REMARKS

The office action of May 5, 2005 has been carefully considered together with the prior art references that have been cited and applied. It is noted that claims 23-31 have been withdrawn from consideration, that claims 38 and 39 have been allowed and claims 41-43 have been objected to. The remaining claims have been rejected under one or more of §§ 112, 102 and 103. These rejections will be individually addressed.

FIG. 1

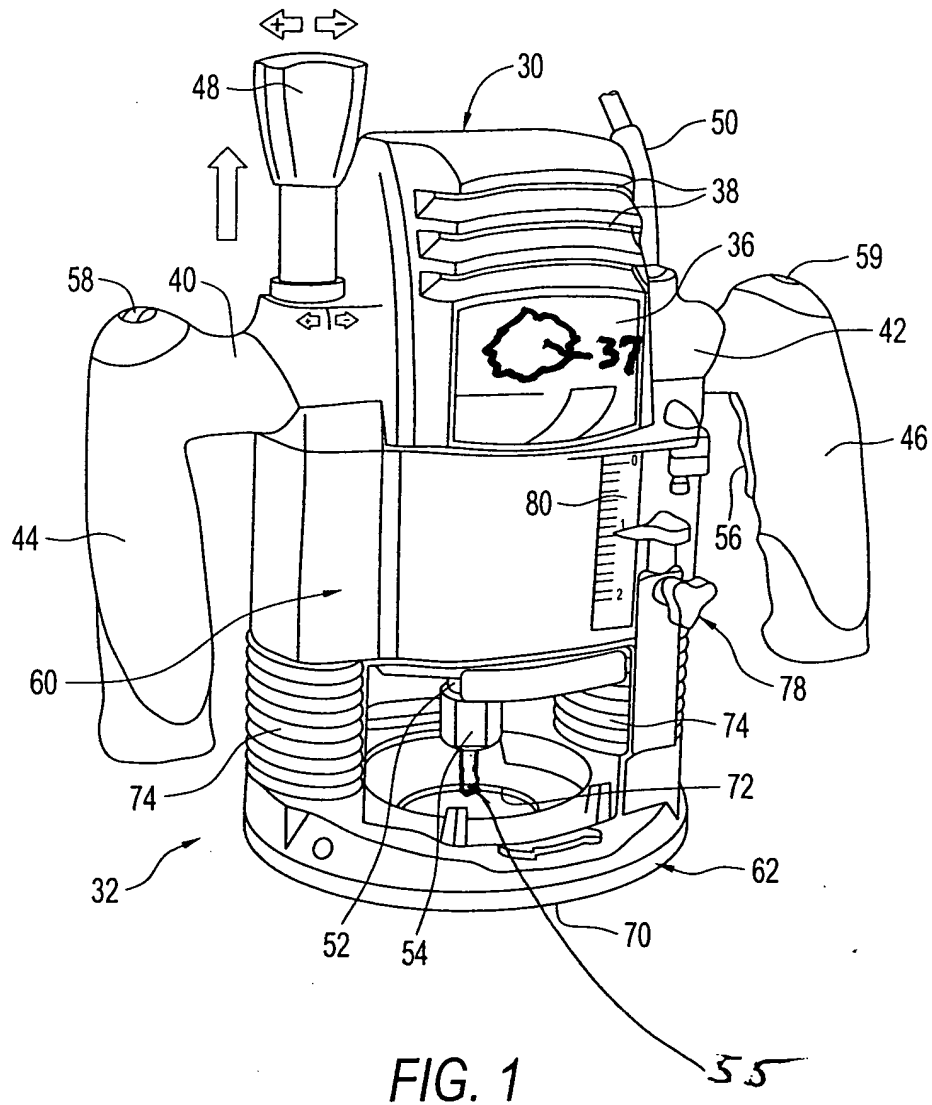
While the examiner's objection to the drawing elevates form over substance, Figs. 1 and 2 have been revised to illustrate the existence of the motor which is shown as a result of breaking away some of the housing structure 36. The motor has been given reference number 37. Similarly, a bit 55 has been illustrated in Fig. 1. The specification has been amended at page 6, line 6 to reflect the motor 37 being shown.

FIG. 9

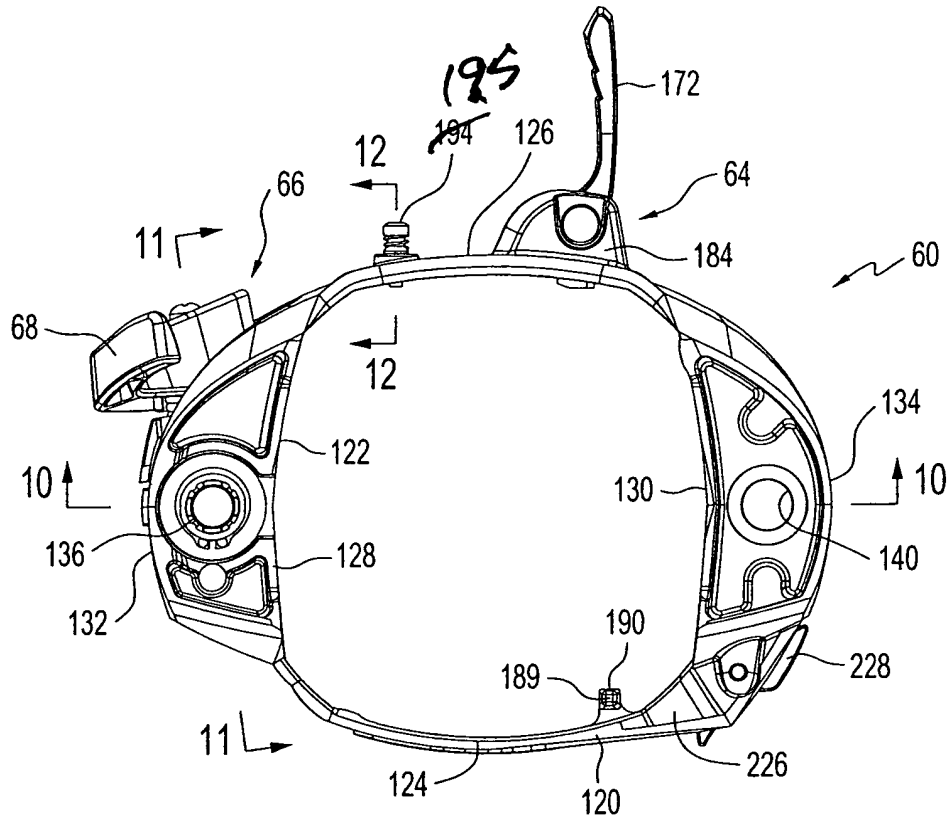
The objection to the drawings because of duplication of reference numbers or errors in the specification have been corrected by the above-referenced specification amendments and by revising Figs. 9, 10, 11, 12 and 13 to change the screw reference number 194 to number 195.
